UNITED STATES PATENT AND TRADEMARK OFFICE

APPLICATION NO.	FILING DATE	FIRST NAMED INVENTOR	ATTORNEY DOCKET NO.	CONFIRMATION NO.
10/014,520	12/14/2001	Gene Parunak	10255-018-999	3929
26161	7590	09/22/2006	EXAMINER	
FISH & RICHARDSON PC			SINES, BRIAN J	
P.O. BOX 1022			ART UNIT	PAPER NUMBER
MINNEAPOLIS, MN 55440-1022			1743

Office Action Summary

DETAILED ACTION

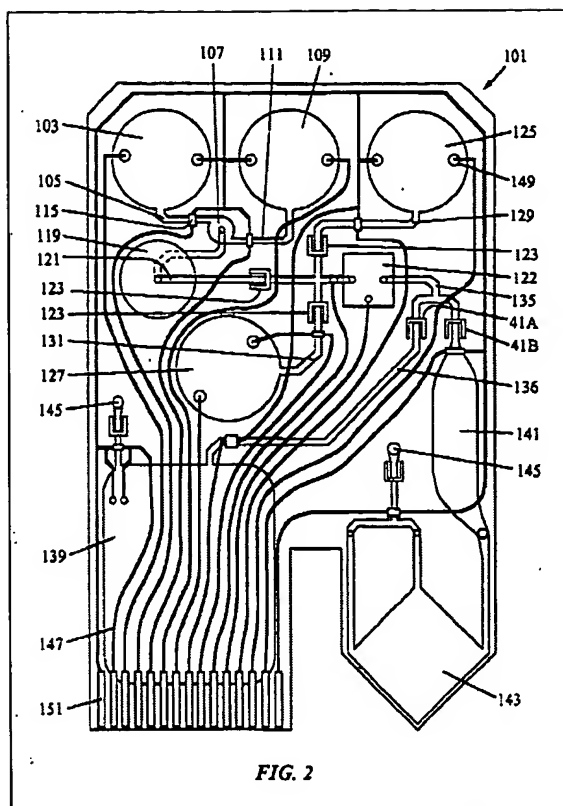
Regarding claims 1, 9, 15, 18 - 20, 26, 30, 40 and 53, Pourahmadi teaches an apparatus (cartridge 101) comprising: a sample port (103); a first channel (105); a lysing zone (lysing chamber 119); and second channel (121) leading downstream from the enrichment zone (see

paragraphs 0044 & 0048; figure 2). Pourahmadi teaches the incorporation of an input means for facilitating the introduction of reagents and test samples into the device (see col. 11, lines 1 – 53). Pourahmadi further teaches that the apparatus can also incorporate one or more filters (e.g., a partitioning structure) for capturing sample components, e.g., cells, spores or microorganisms to be lysed. The filters may also be used for removing particulates, cell debris and protein solids from the sample. The filters may be within any region, e.g., within the fluid passages or channels leading between regions or within a particular interactive region (see paragraph 0099). Thus, it would have been obvious to a person of ordinary skill in the art to incorporate an enrichment zone or chamber, which comprises a flow-through filter member, positioned upstream of the lysing chamber of the apparatus. In addition, Pourahmadi teach the incorporation of specific electrode configurations comprising a detection zone to allow for the electrochemical detection of chemical constituents in a processed sample (see paragraph 0135). Therefore, it would have been obvious to a person of ordinary skill in the art to incorporate a detection zone disposed downstream of the enrichment zone to monitor the chemical composition of processed samples.

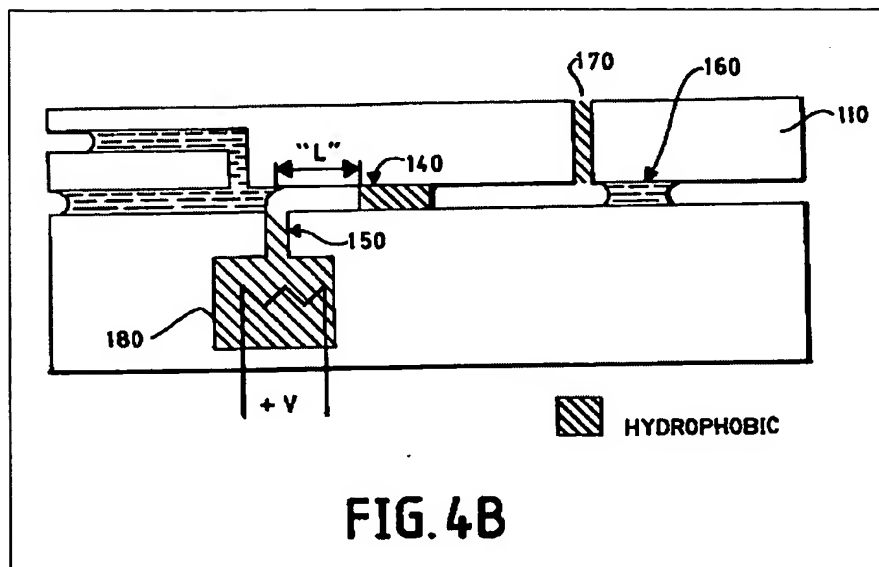
Handique teaches a thermopneumatic apparatus comprising a gas actuator for facilitating fluid transport in microfluidic devices (see col. 13, line 60 – col. 15, line 40; figures 3A, 3B, 4A & 4B). As shown in figure 4B, the system taught by Handique comprises a thermopneumatic

actuating system denoted by 180, a hydrophobic gas vent (170), a positioning element (hydrophobic region 140), and an outlet, which is located to the right of the sample (160) and at the end of the channel containing the sample, from which the sample is transferred for further processing, such as to a lysing chamber for cell lysing, when integrated within an analytical microfluidic system.

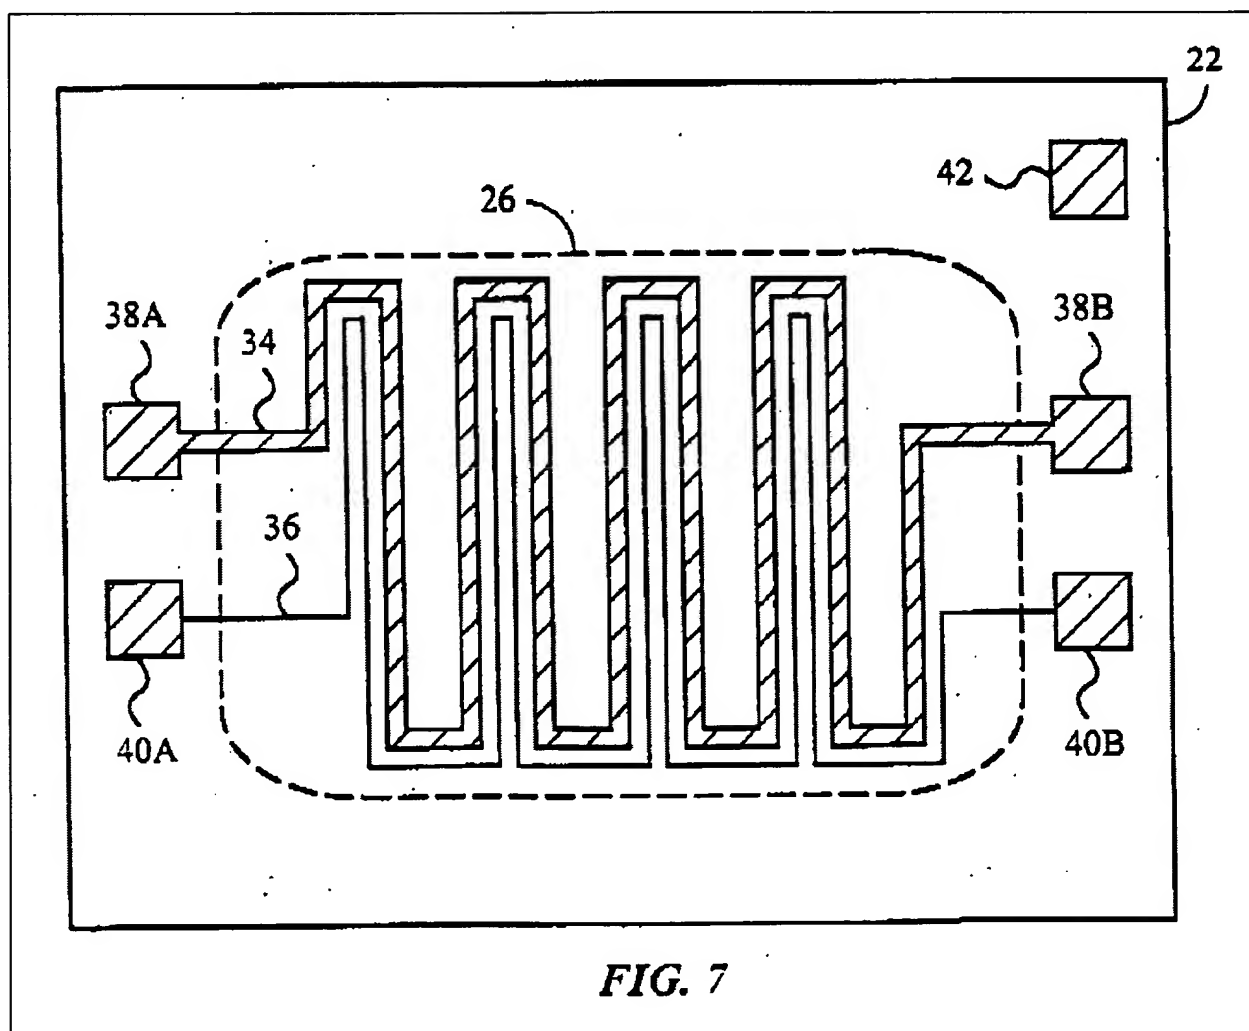
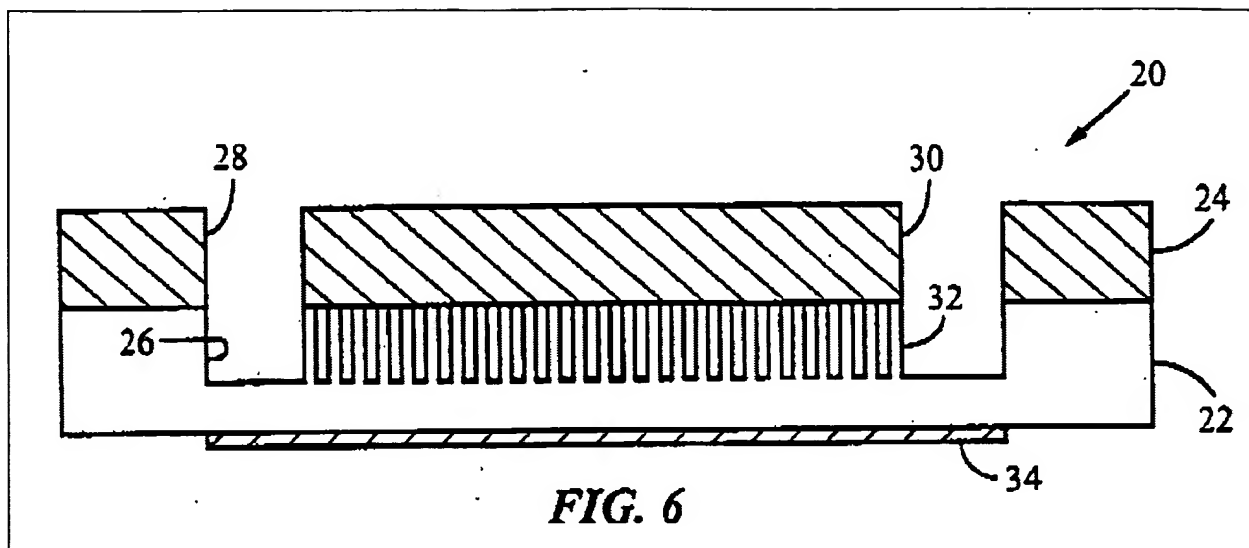
Regarding claims 6, 7, 23, 24, 44 – 46 and 54 – 56, Handique suggests the incorporation of valves, which are well known in the art, with the hydrophobic vents (70 & 170) for opening and closing the vents for facilitating sample fluid transport. Handique also teaches the use of thermally-actuated valves (see col. 14, lines 51 – 57; col. 16, lines 40 – 61; figures 3A, 3B, 4A & 4B) (see MPEP 2144.03). In addition, Pourahmadi also teaches the incorporation of various valves within the disclosed microfluidic apparatus to provide means for controlling fluid transport within the disclosed apparatus (see, e.g., paragraph 0052). Therefore, it would have been obvious to a person of ordinary skill in the art to provide a plurality of valves within the apparatus as claimed in order to facilitate effective sample fluid flow within apparatus.

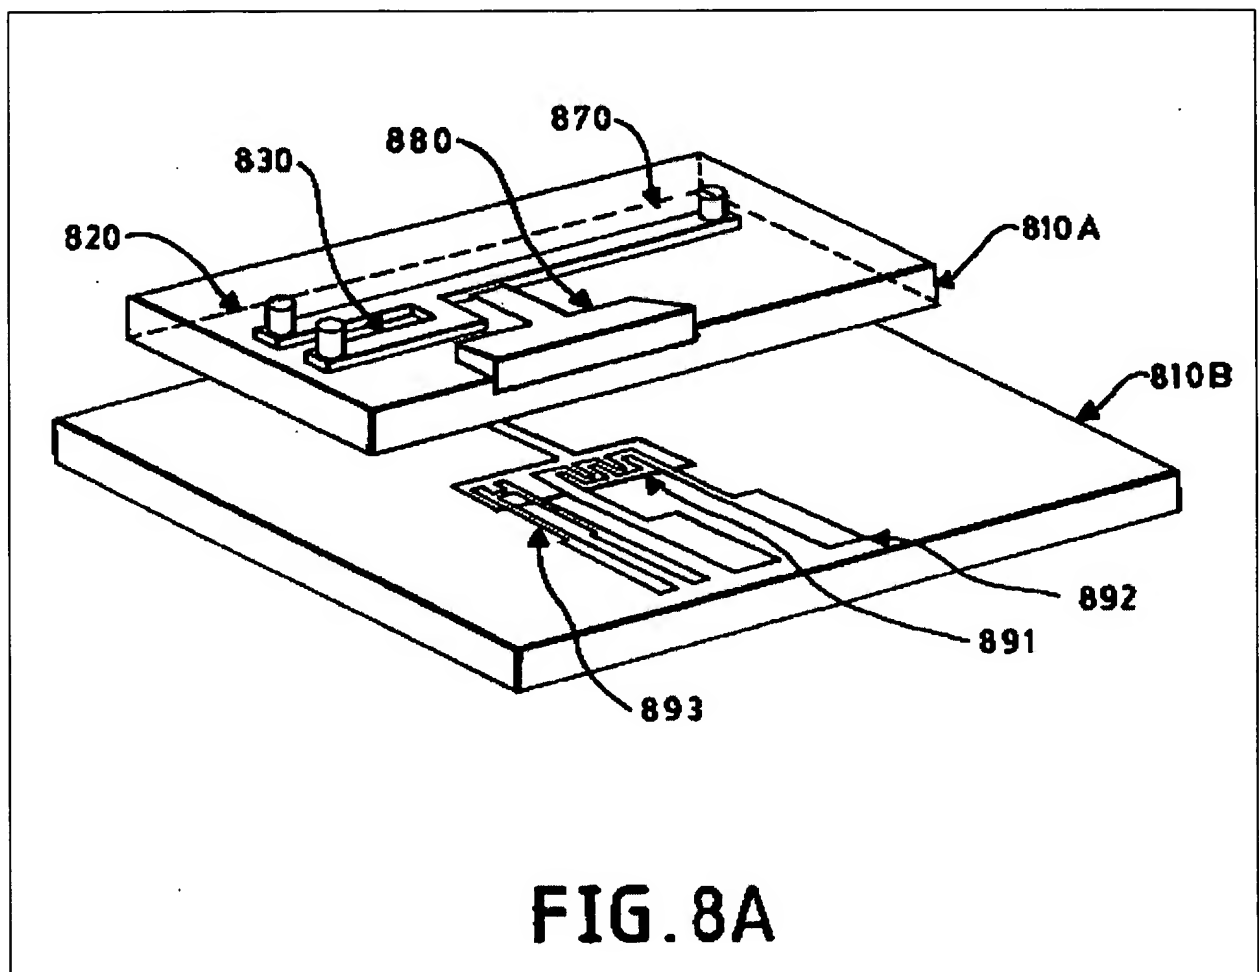
Handique teaches a microfluidic device configuration comprising a lower silicon dioxide substrate 810B and an upper glass substrate 810A. The bottom surface of the upper glass substrate 810A has channels and chambers etch into it. The lower silicon substrate comprises a heating element 891 (see col. 20, lines 5 – 13; col. 26, lines 1 – 29; figure 8A). The resistive heating elements comprise a metallic aluminum film (see col. 20, lines 13 – 22). The substrate layers are bonded together (see, e.g., col. 21, lines 29 – 33).

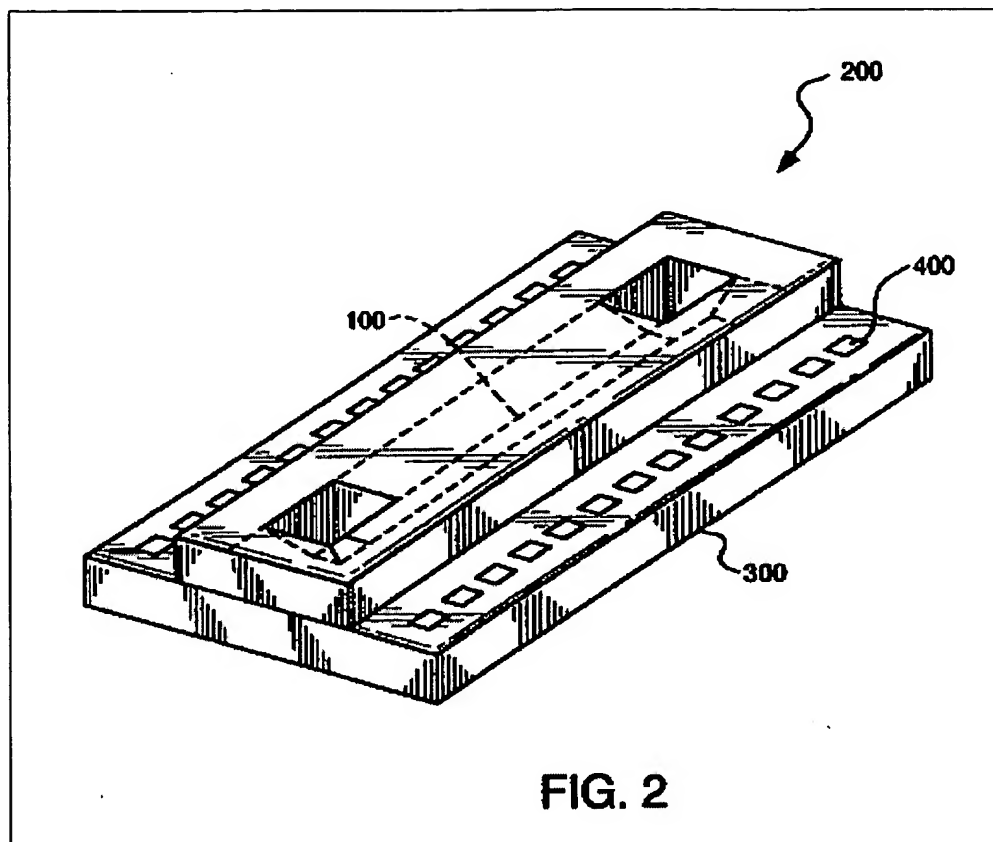
Handique further teaches a device configuration comprising a lower substrate 300 having a base comprising glass and an upper substrate 200 comprising silicon. The top substrate 200 has microchannels 100 (see col. 13, lines 48 – 59).

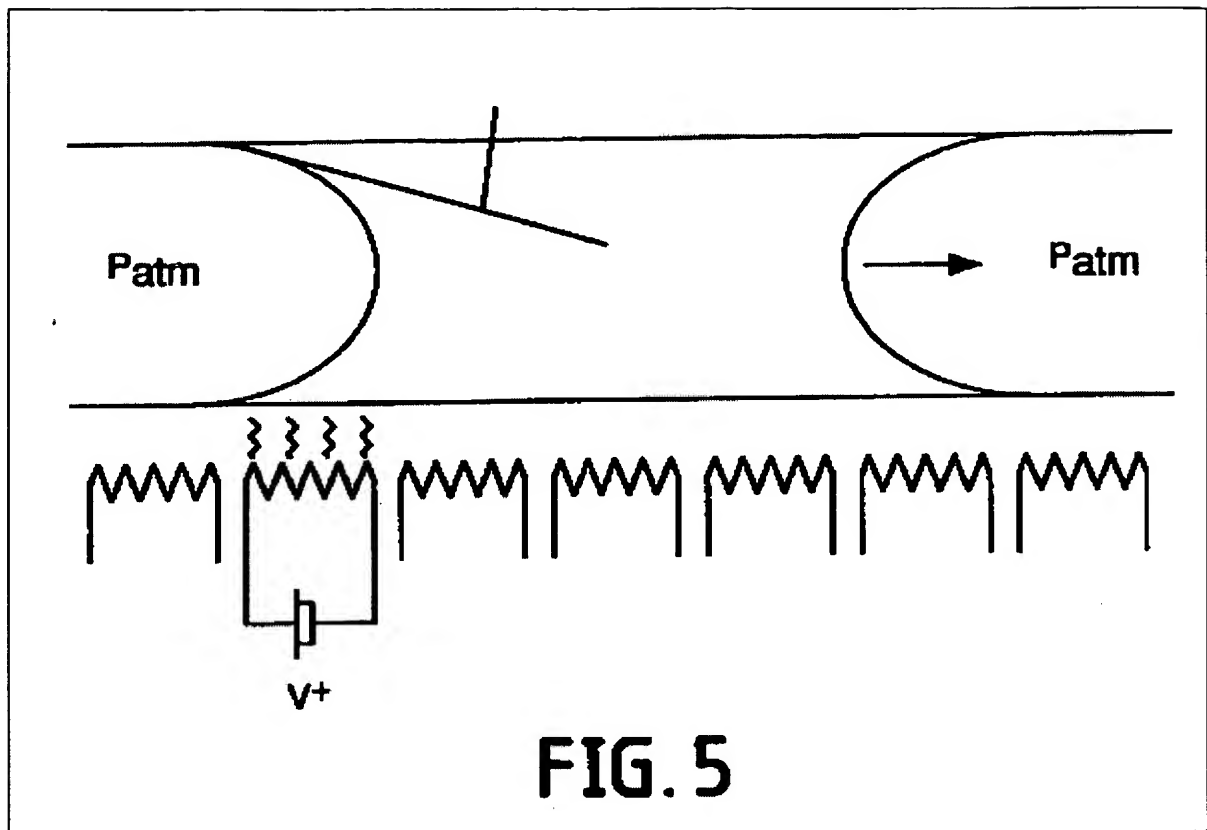
As indicated in figure 5, a plurality of successive heaters can be arranged in a substrate and along the length of a channel for facilitating fluid transport through the channel (see col. 15, line 41 – col. 16, line 23).
